Florida Power

CORPORATION
Crystal River Unit 3
Docket No. 90-002

August 20, 1997
3F0897-09

Subject: Request for Additional Information Regarding Technical Specification
Change Request Notice No. 211, Revision 0

FIGURE 1
 Page 1 of 1

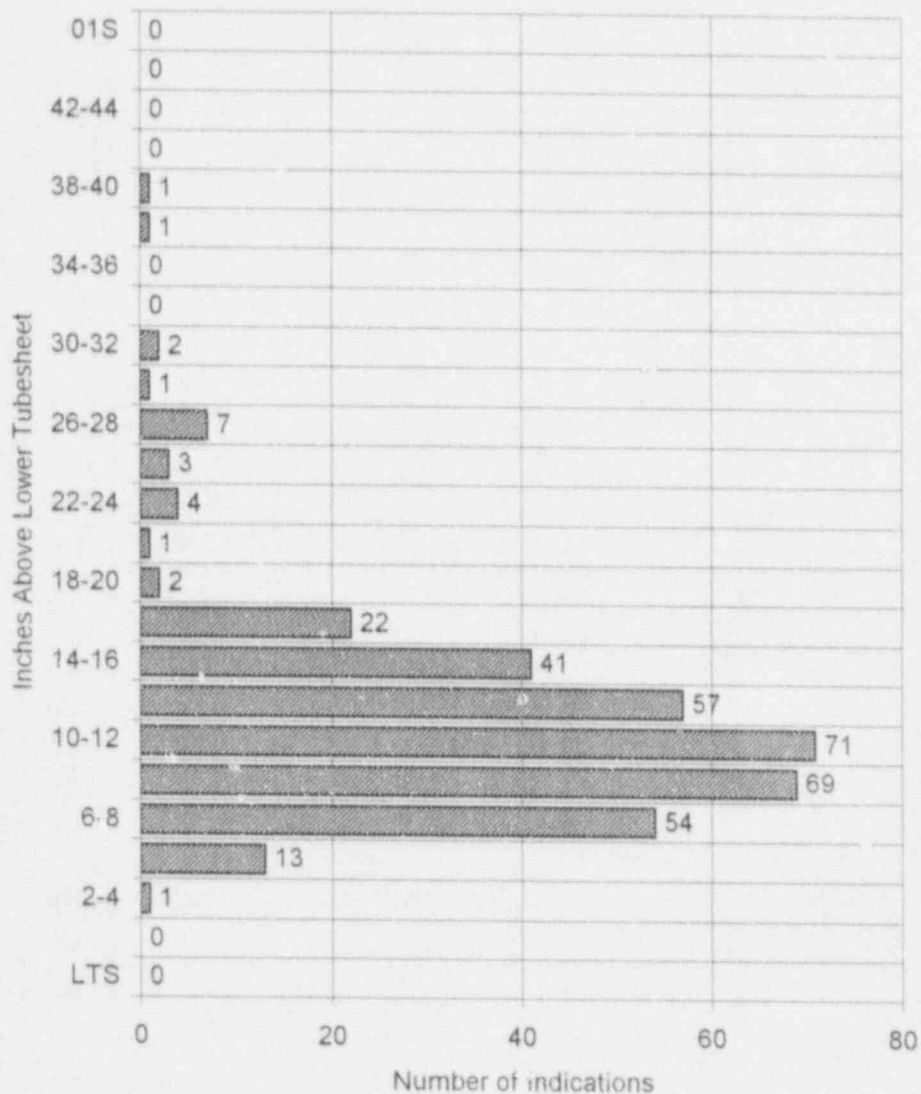
The "first span" region is defined as the section of tubing between the lower tubesheet secondary face and the bottom of the first tube support plate. The staff notes that based on industry experience in applying an eddy current depth sizing technique to indications at support structures that applying the technique near the first span boundary could lead to significant, non-conservative errors in estimated depth inconsistent with the results of the qualification program. The proposed TS changes would allow degradation at or near the tubesheet or first support plate to remain in service based on the eddy current sizing technique. Provide the basis for not including an allowance in the definition of the first span region that could preclude introducing errors into the depth estimate of degradation located at or near the periphery of the first span.

CR-3 will not leave tubes in service with first span IGA indications within one inch of the edge of the lower tubesheet secondary face (LTS+1) or within one inch of the first support plate lower edge (OIS-1.75" since the support plate is 1.5" thick and measurements are referenced from the centerline of the support plate). B OTSG first span IGA tubes with indications in these regions will be plugged regardless of %TW. As a result of the 1997 inspections, there are no tubes with known IGA indications within 2 inches of the LTS secondary face or tubes with known IGA indications within four inches of the lower face of the first support plate. Figure 1 shows the distribution of first span IGA indications left in service after the 1997 inspection.
